# EASTERN CORRIDOR SEGMENTS II AND III (PID 86462) US 50 CORRIDOR FOCUS AREA ADVISORY COMMITTEE MEETING NOTES

## Meeting Dates

Figure I-11C

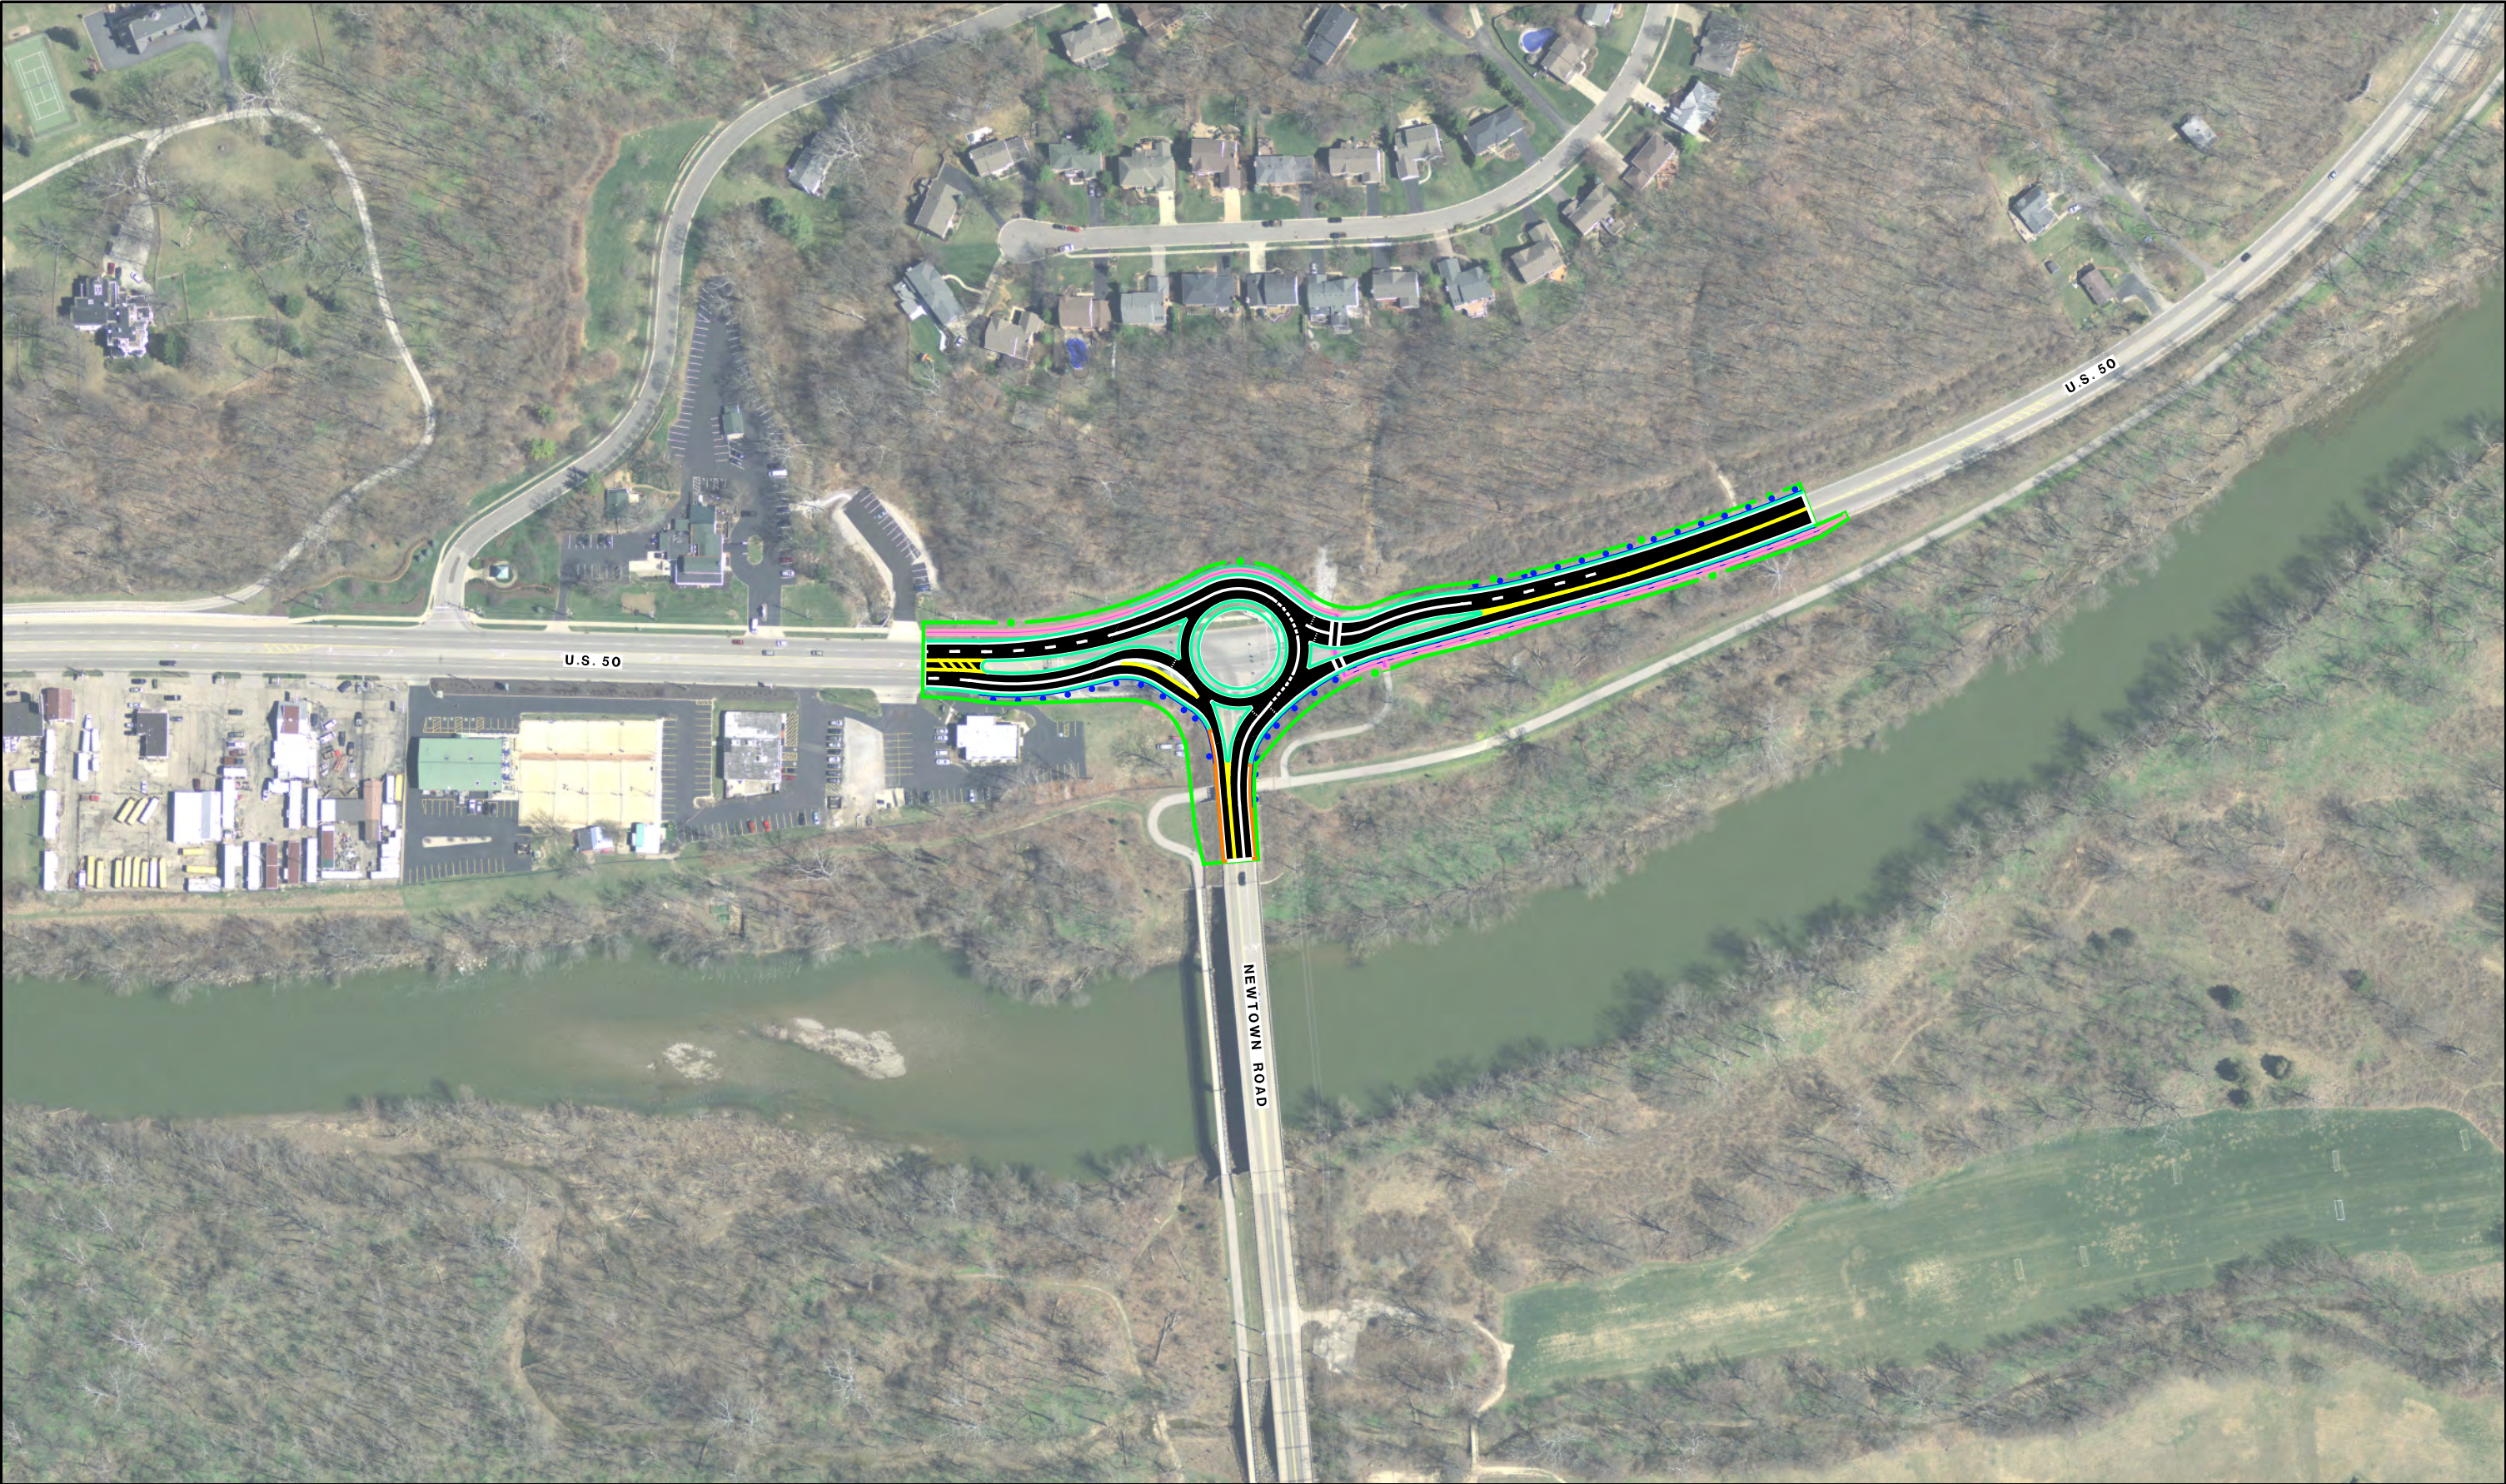
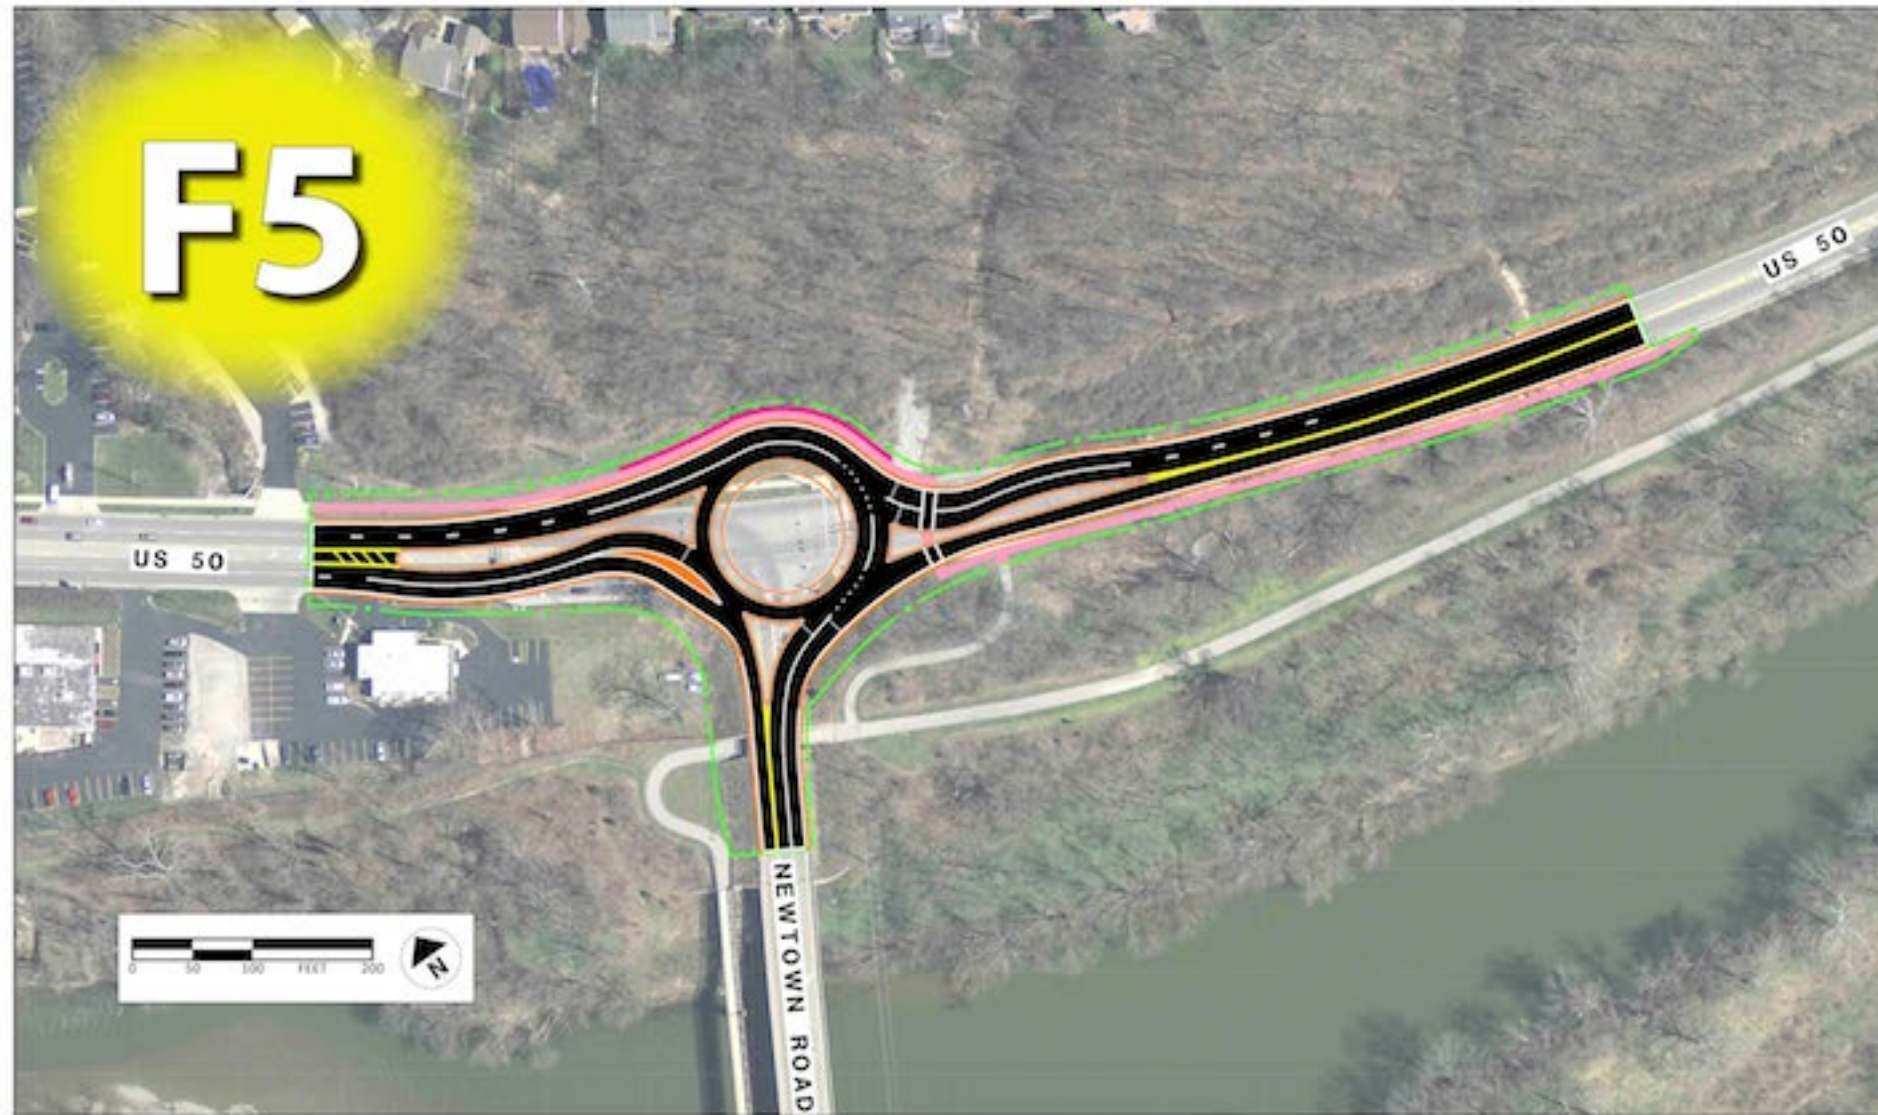
- Major traffic flow change will require community input. ODOT needs to verify Figure I-11c is drawn to scale and is sized to allow trucks and

- Include concept in the Implementation Plan as a medium priority.
